AMENDMENTS TO THE DRAWINGS

FIG. 2

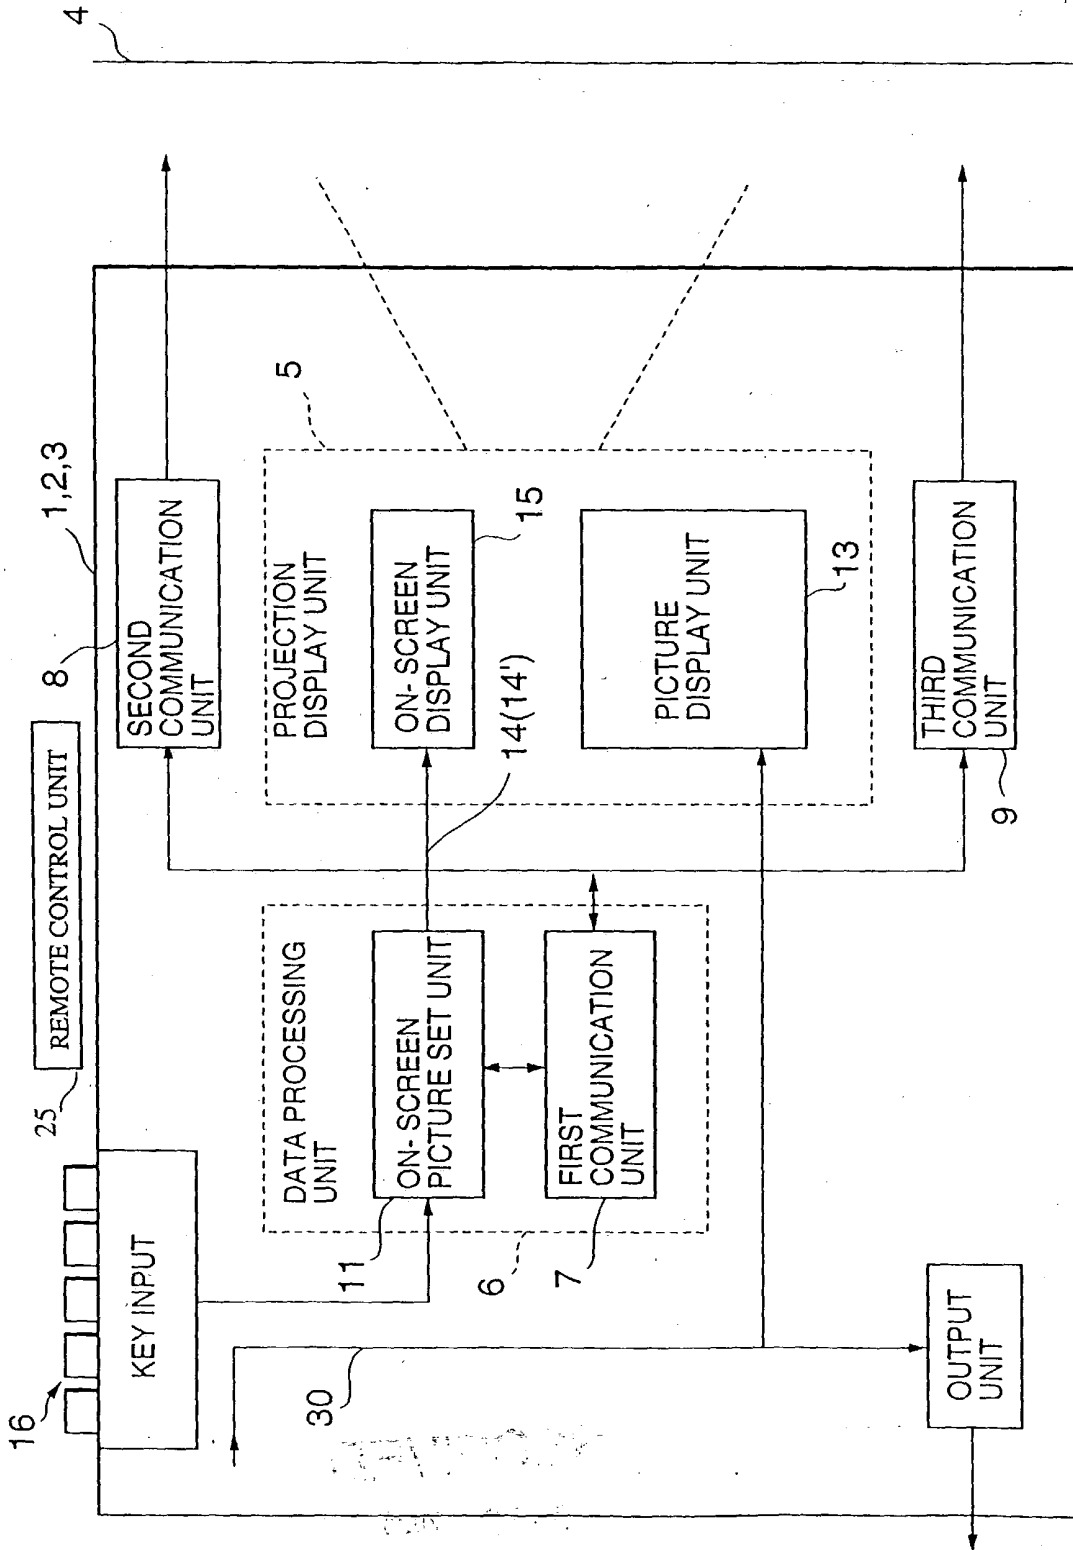
In Fig. 2, the feature “remote control unit 25” is added.
